Date: April 17, 2024

**Project/File:** **Multi-Family Building/ GC24-0006/ DSRFY2024-0008**

This is a design review application to allow for the construction of a multi-family building consisting of 12-units on 0.4-acres. The site is located at the northeast corner of Alworth Street and 50<sup>th</sup> Street.

**Lead Agency:** Garden City

**1 SITE PLAN**

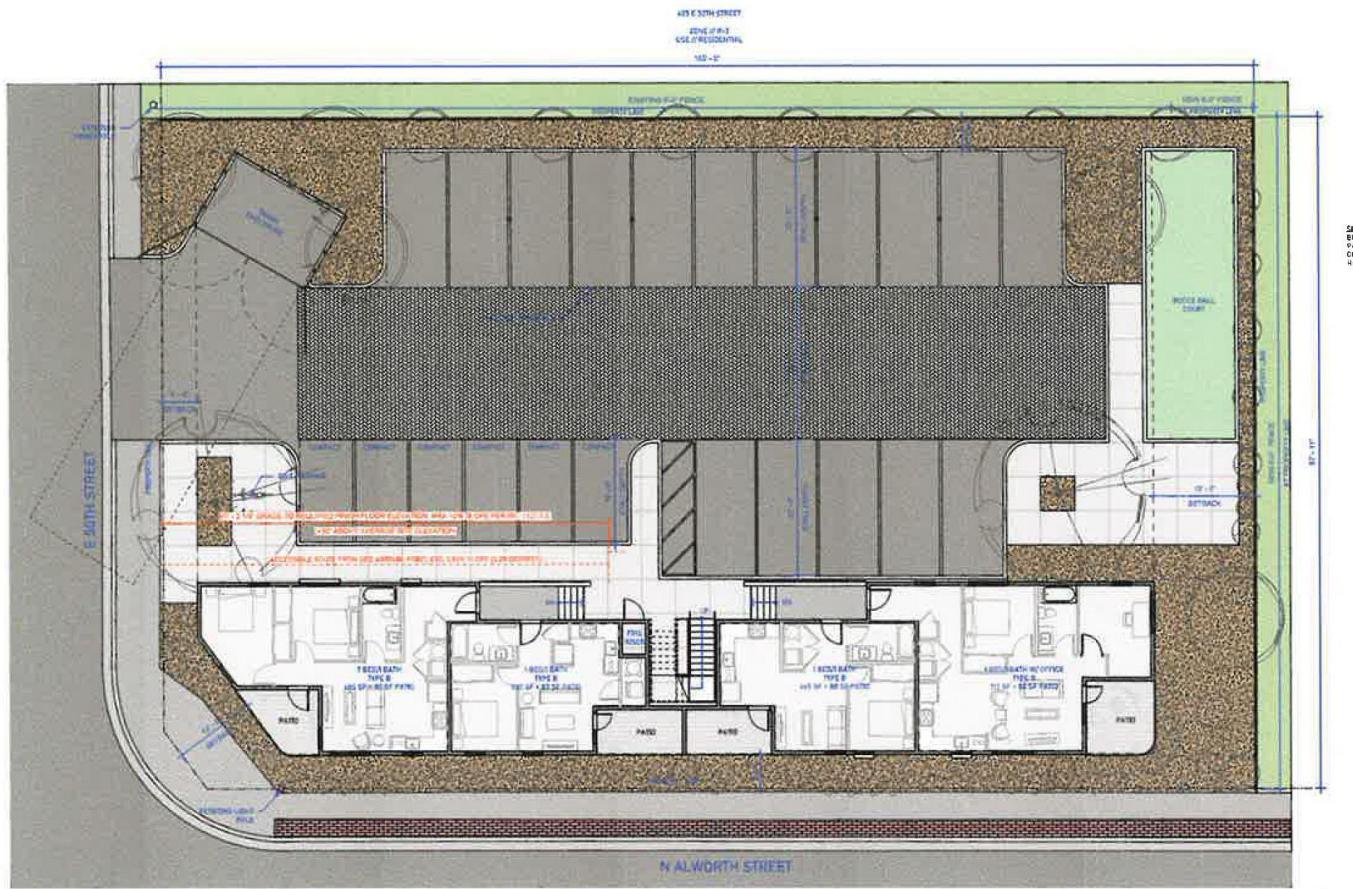
- a. Existing Conditions:** There are no existing driveways from the site onto Alworth Street.
- b. Staff Comments/Recommendations:** Direct lot access should be prohibited to Alworth Street, as this site has access to 50<sup>th</sup> Street, a local street.

- c. Staff Comments/Recommendations:** The applicant's proposal to close the existing driveway onto 50<sup>th</sup> Street located 57-feet north of Alworth Street with vertical curb, gutter and 7-foot wide attached concrete sidewalk to tie into the existing improvements on either side meets District policy and should be approved.

The applicant's proposal to construct a 27-foot wide paved curb cut type driveway onto 50<sup>th</sup> Street located 93-feet north of Alworth Street does not meet District Driveway Location policy which requires driveways to be located a minimum of 150-feet from the nearest collector street

intersection. However, staff recommend approval of the proposed driveway location, as the driveway is needed to serve the site and there is not enough frontage to meet the offset requirement.

2. Close the existing 17-foot wide driveway onto 50<sup>th</sup> Street located 57-feet north of Alworth Street with vertical curb, gutter and 7-foot wide attached concrete sidewalk to tie into the existing improvements on either side, as proposed.

3. Construct a 27-foot wide paved curb cut type driveway onto 50<sup>th</sup> Street located 93-feet north of Alworth Street, as proposed.
4. Direct lot access is prohibited to Alworth Street.
